# PERMIT

SEWAGE DISPOSAL SYSTEM

HOWARD COUNTY

SUBDIVISION ROAD 5178 Ten Oaks Road LOT

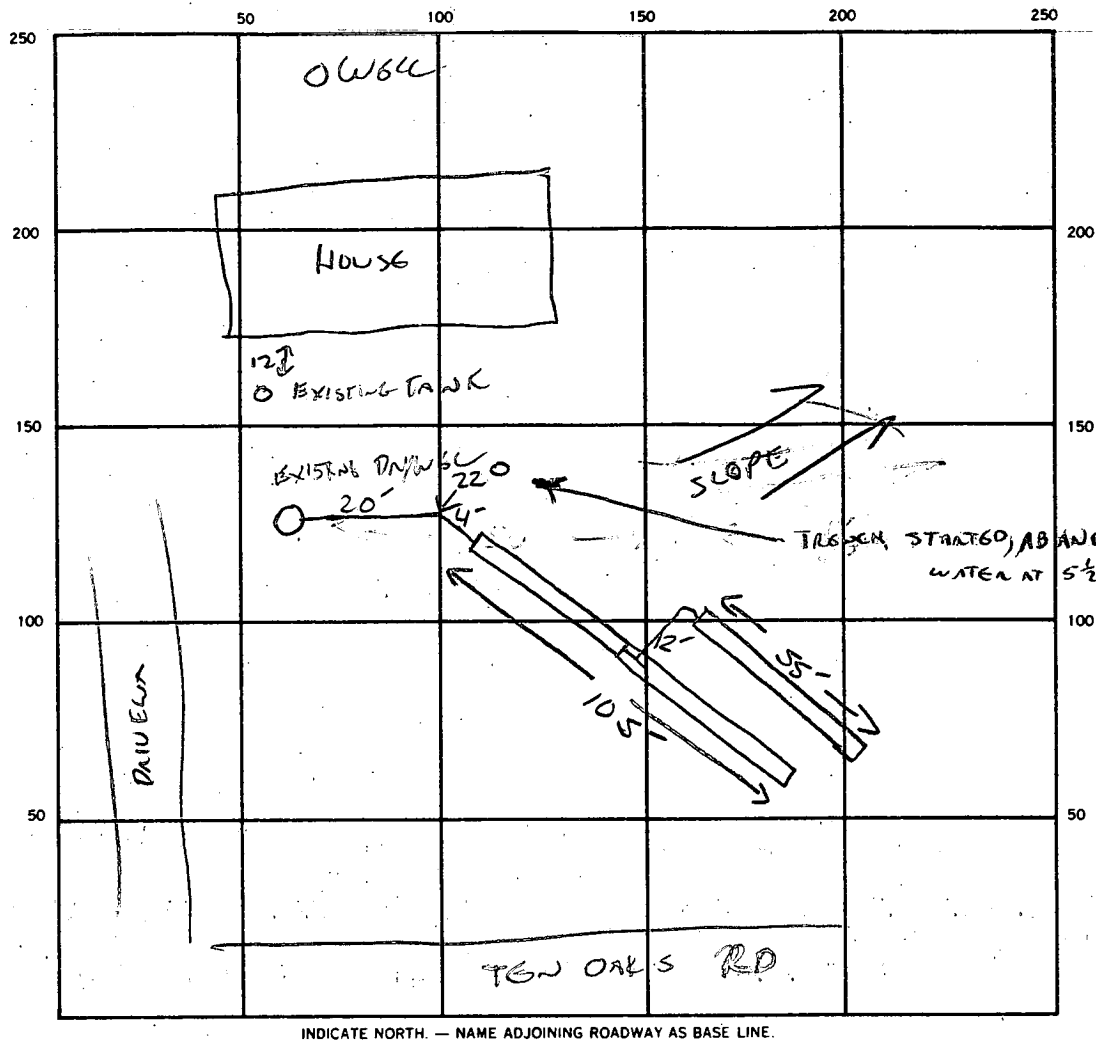
WATER TO 6' IN TRENCH AREA. MOVE UPHILL &amp; INSTALL 150' OF TRENCH 3' W 106.

AS SHALLOW AS POSSIBLE

REMARKS 150' SHALLOW TRENCH 3' WIDEB REQ'D, 5/11/88 CW
